# SERVICE BULLETIN #1057

SUBJECT Fraying of Starter Rope By Anchor Rivet

MODEL **MAC 35**, MAC 35A, 35, 39, D44, S44, S55, S44A, S55A

DATE 5/21/59

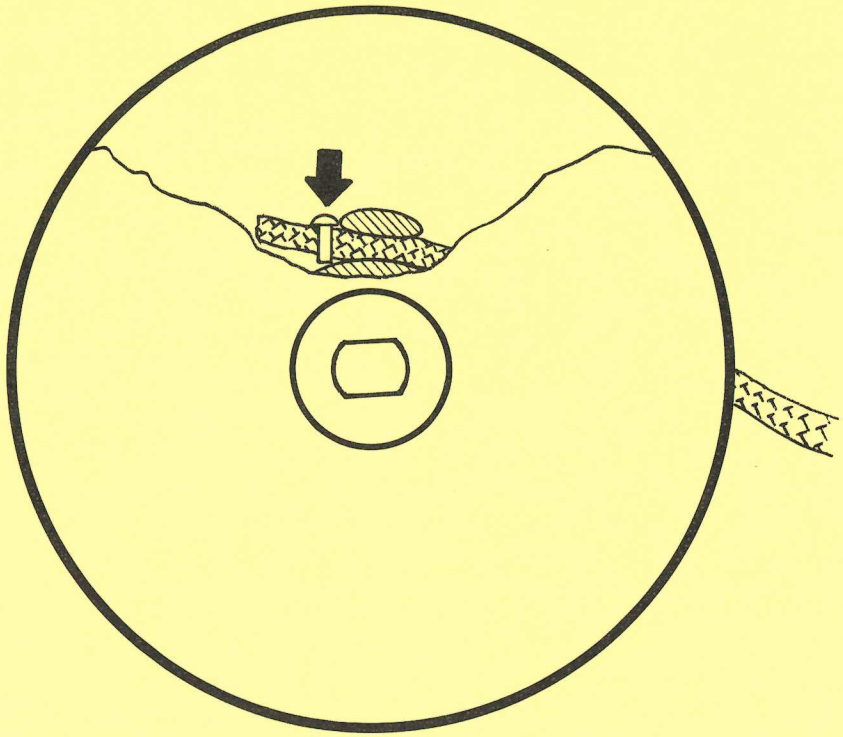
To prevent fraying of the starter rope by the anchor rivet, P/N 103697, the following method of installing a new starter rope is recommended.

1. Heat-seal ends of the rope fibers to prevent unraveling.
2. Insert end of starter rope through the hole in starter drum.
3. Insert anchor rivet in starter rope approximately one-half inch from rope end.
4. Dip rope and rivet into "Seal-All" about one inch and allow to dry.
5. Place anchor rivet in position as shown in illustration with the rivet head facing towards the outer rim of the starter drum.
